Subject: Work Plan Addendum Request; Fuel Leak Case No. RO0003140; (Global ID # T10000005974); DeLong Oil, 1716 Webster Street, Alameda, CA 94501

Alameda County Environmental Health (ACEH) staff has reviewed the case file including the *Site Status Report and Data Gap Work Plan*, dated July 31, 2014. The report was prepared and submitted on your behalf by Alfa Environmental Remediation Services, Inc (Alfa). Based on the information contained in the referenced report ACEH has sufficient concerns in regards with ACEH's previous directives and damage to site groundwater monitoring wells to request an addendum to the work plan prior to approval of work at the site. ACEH also has concerns in regards to the appropriateness of the proposed soil bore locations as described further below.

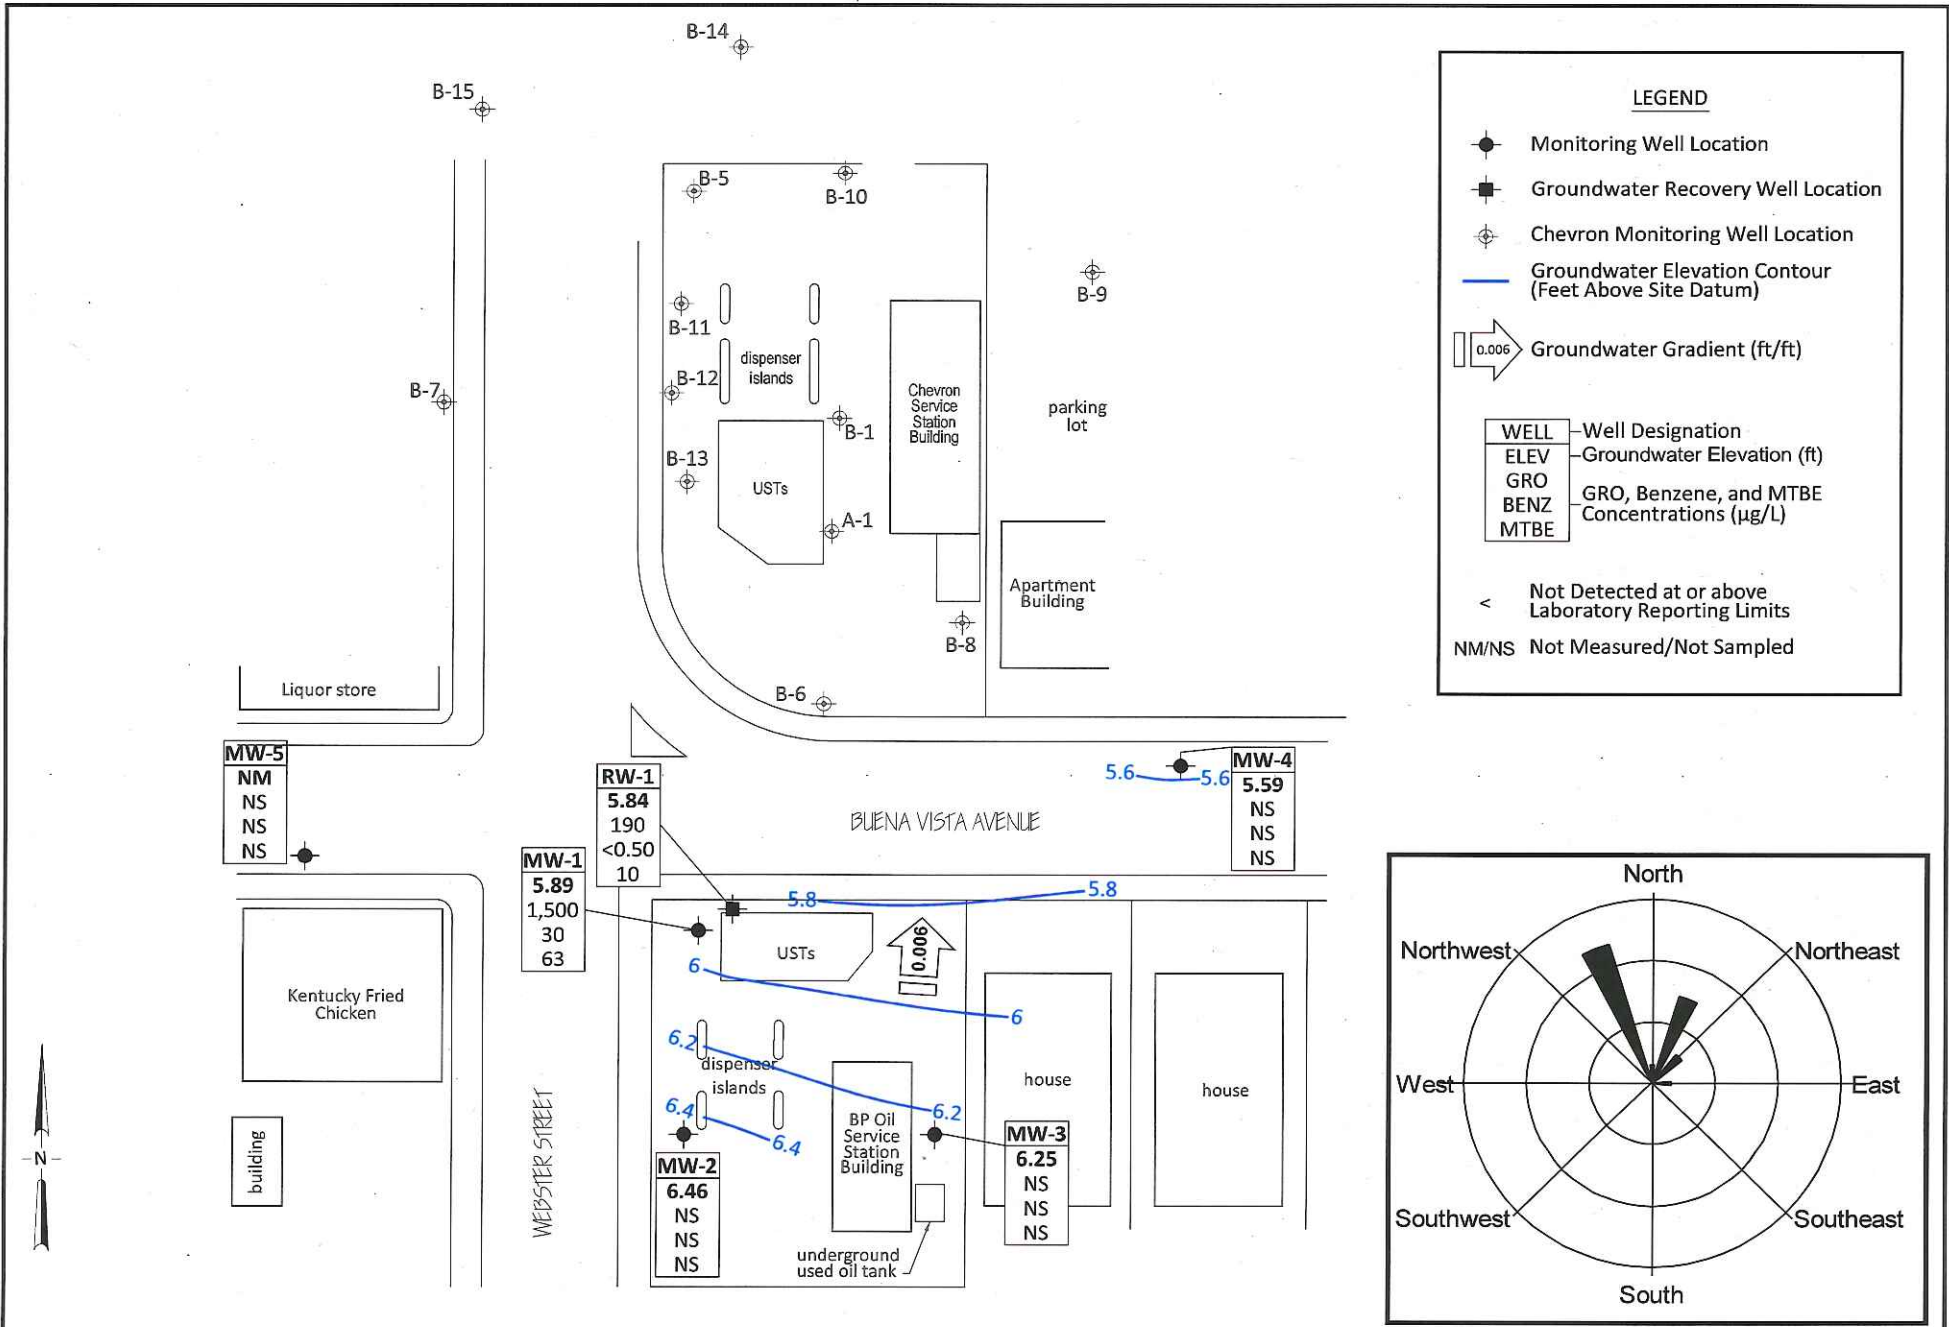
1. **Condition of Wells MW-1 and RW-1** – The referenced report included photographs of the surface completion of wells MW-1 and RW-1. It appears that surface pavements around the wells are currently in a state of good repair; however, photographs taken on June 6, 2014 by Broadbent & Associates indicate otherwise (attached). The June 10, 2014 Notice to Comply letter requested multiple lines of evidence that the wells are suitable for monitoring and sampling at the site. These included the tagging of total well depths to determine if sediment has partly or entirely filled the well bore, downhole camera survey results as appropriate, and a resurvey of repaired wells to Geotracker standards to validate well elevations and locations. If otherwise, the wells will also require destruction and replacement by DeLong Oil. These tasks were not conducted, proposed, or discussed in the referenced work plan, and are requested to be incorporated into a work plan addendum, by the date identified below.

Groundwater Elevation Contour and  
 Analytical Summary Map  
 August 8, 2013

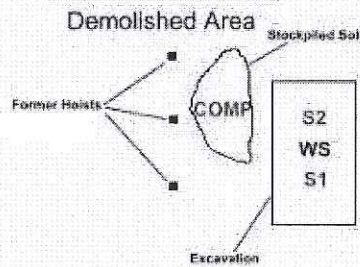
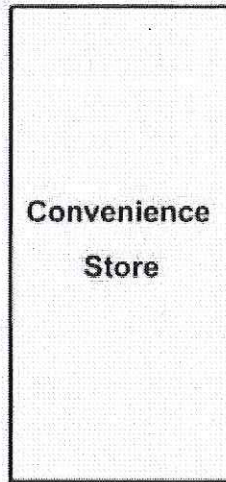
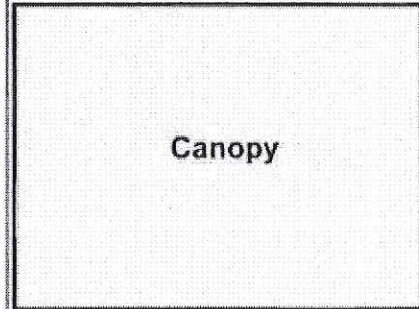
- c. Location of Well MW-3** - The location of lost well MW-3 has been placed in two different locations relative to the former waste oil UST (see attached figures previously discussed). This affects the ability to relocate the well for the proposed well destruction under permit. This may also affect well MW-2, also proposed to be destroyed, should the surface expression of the well have also been lost. The use of Geotracker survey coordinates for both wells will assist in this effort for the figure and in the field.

**Proposed Soil Borings - Location Map**

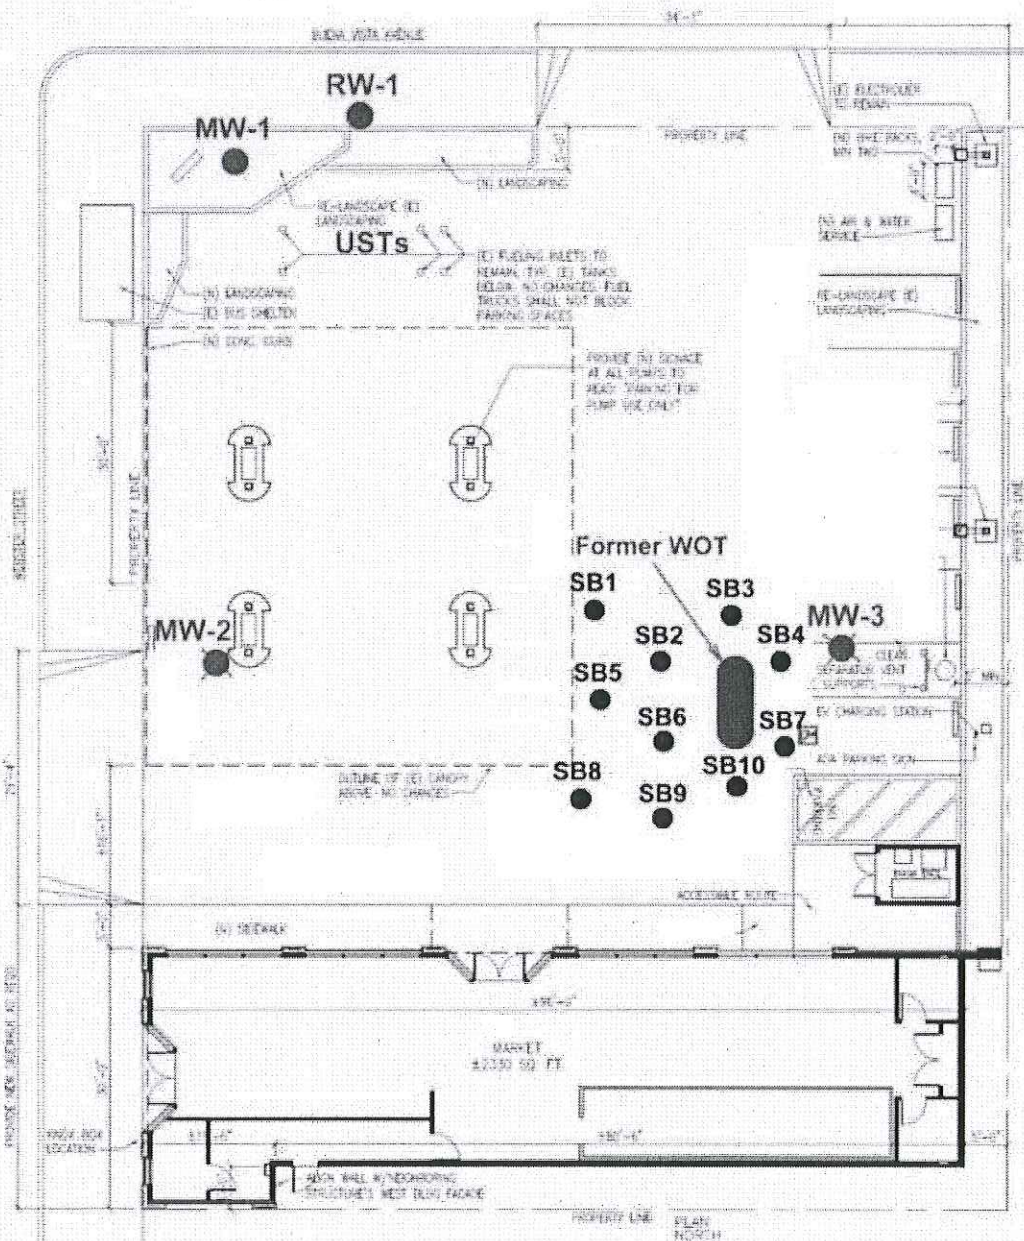
- a. **Placement of Bores** - The work plan proposed the installation of 10 soil bores around the location of the former waste oil underground storage tank (UST); however, the figure placed the location of the former waste oil UST at a new location in the southeastern corner of the site. This is at least the third location depicted in site figures (see attached figures); thus ACEH cannot determine the appropriateness of the bore locations as this may cause the bores to be installed at an incorrect location that would not adequately characterize the former waste oil UST location.

- b. **Accuracy of Figure** – Part of the inability to determine the appropriateness of the bore locations, may be associated with the accuracy of the figure. The new market building is indicated to be 30 feet in depth north to south; however, the bar scale associated with figure

indicates the north to south dimension should be approximately 11 feet (1 foot to 1/8 inch). Using the 30 foot building depth suggests the former UST was located approximately 53 feet north of the southern property line, whereas previous figures indicate it was between 17 and 22 feet. Photographs available to ACEH indicate the former waste oil UST was located to the east of the former service station building, towards the southern end.

- d. Request for Revised Figure** – As a consequence of these concerns, ACEH requests revisions to the figure, including the depiction of the outline of the former service station building in the background field of the figure (grayed out or other method to depict a former structure), in order to determine the appropriateness of the proposed scope of work prior to work approval. Please submit the revised figure in the requested work plan addendum by the date identified below.
